**RE: Le-O-Na Falls Mobile Home Park Reconnaissance Inspection
NPDES Permit No. 1PV00123*AD / OH0133698**

NPDES Compliance Inspection Report

Photo 5 – Surface Sandfilter Lift Station

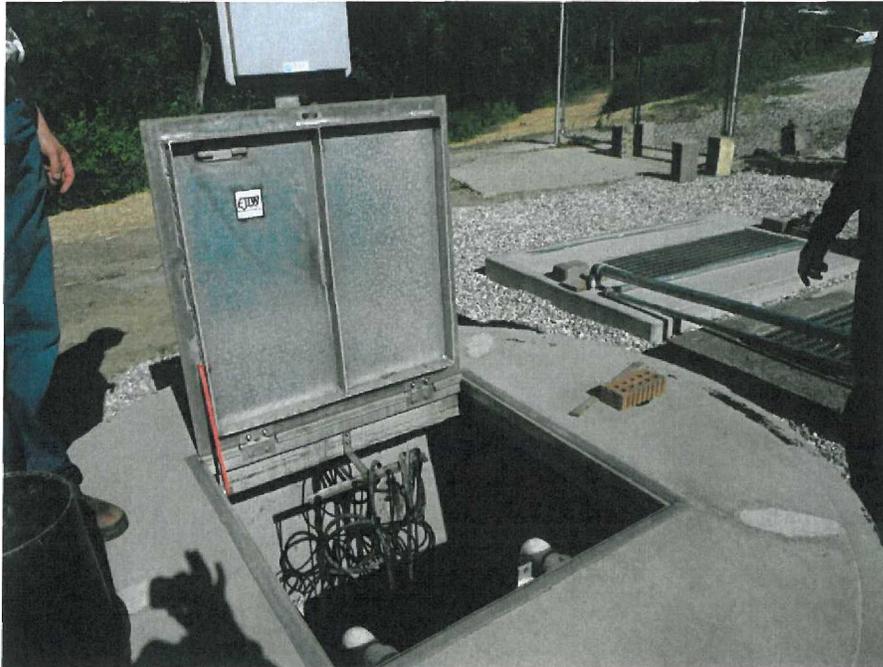
The surface sandfilter lift station was observed and found to be operational. The distribution box for these sandfilter was observed. An upturned PVC elbow was present on the outlet of the south filter. This filter was being rested, as evidenced by the upturned discharge pipe. The surface sandfilters were observed (north and south). The north filter was set up as the active filter. The sand surface of

Photo 7 – Upper Picture: South Surface Sandfilter Lower: North Surface Sandfilter

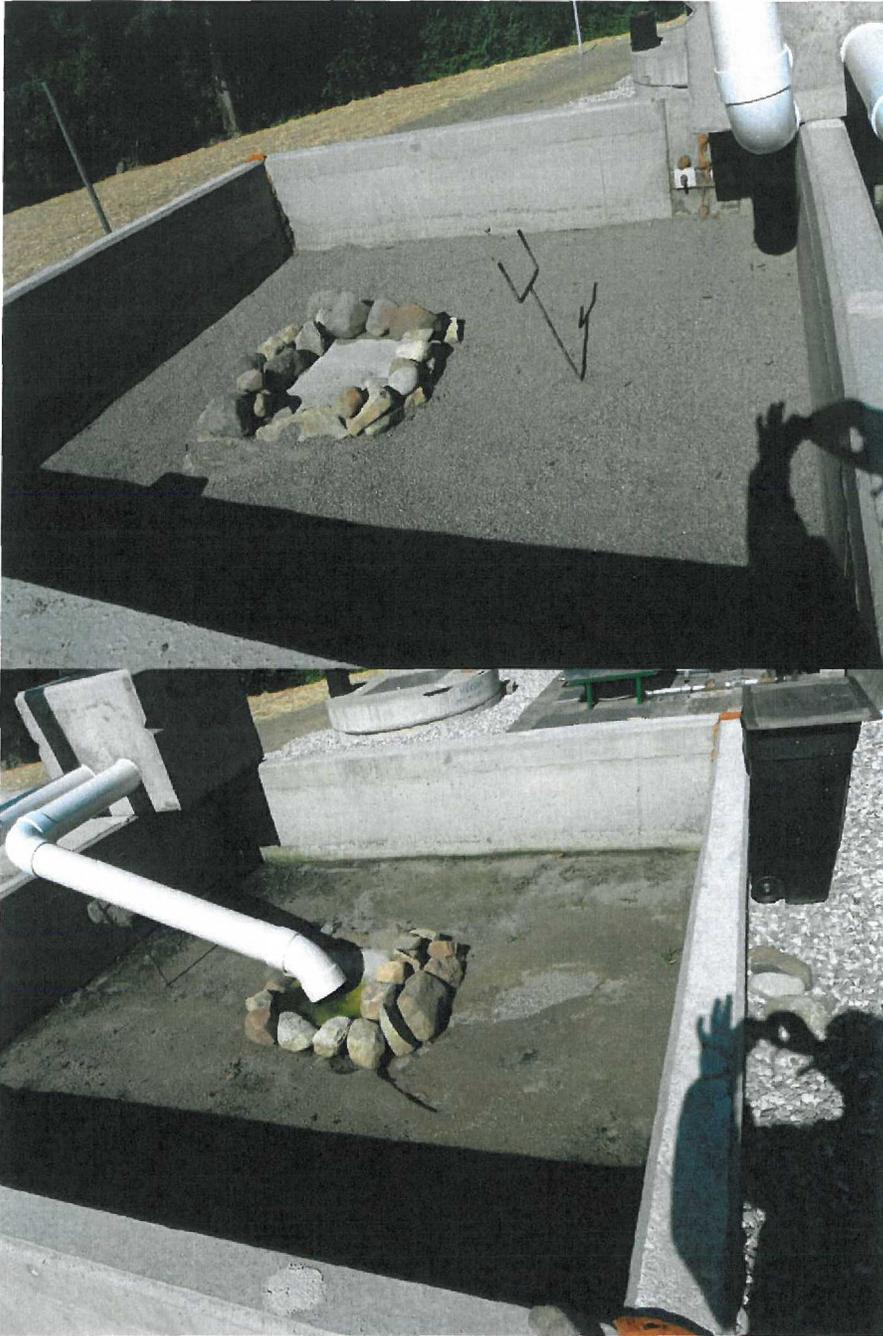
3. Fencing around the wastewater treatment plant. The fencing around the wastewater facility was incomplete. It was evident that this appears to be in progress. Please complete this fencing installation.
4. The North Surface Sandfilter. Erosion (rutting and rilling) was present on the surface of the sand within this filter. Please smooth this sand surface via raking.
5. Surface Sandfilter Pump Station. A brick was covering a four-inch diameter hole in the top of this pump station. It is suspected that this penetration is to be utilized for a vent for the pump station. Please note that the vent typically resembles an upside down J and may be fabricated from PVC pipe.

each filter was free of vegetation. However, it was noted that rilling and rivulets existed on the north sand surface in each filter. The south (resting) filter did not have these features. See Photo 7.

Photo 8 – Ultraviolet Disinfection Unit

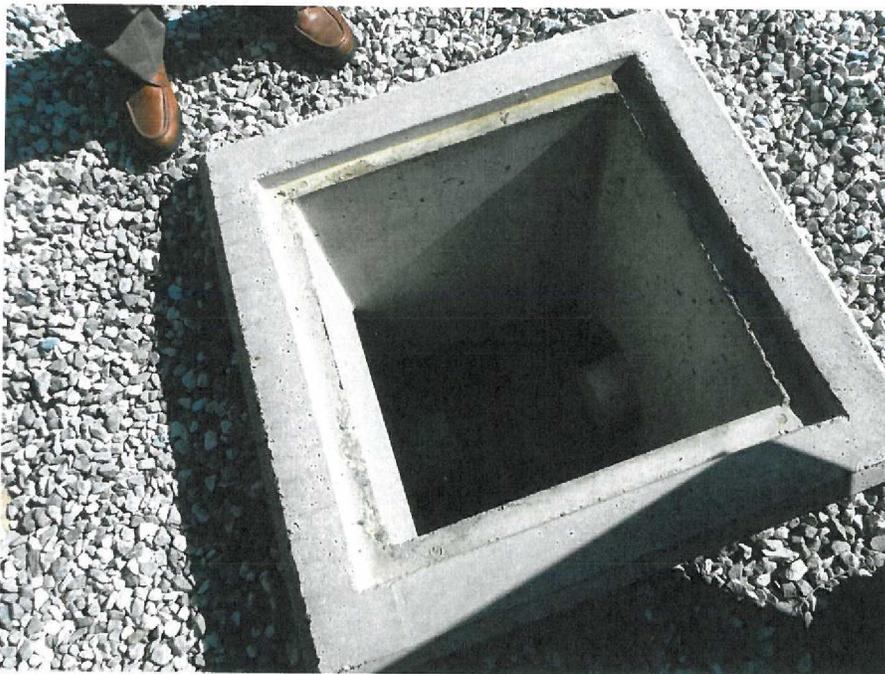
The Ultraviolet (UV) disinfection unit was observed, as well as, the sampling chamber (See Photos 8 and 9). Both units were in very good physical condition. No evidence of solids carryover was noted in either of these locations. The UV unit was noted as being electrically connected.
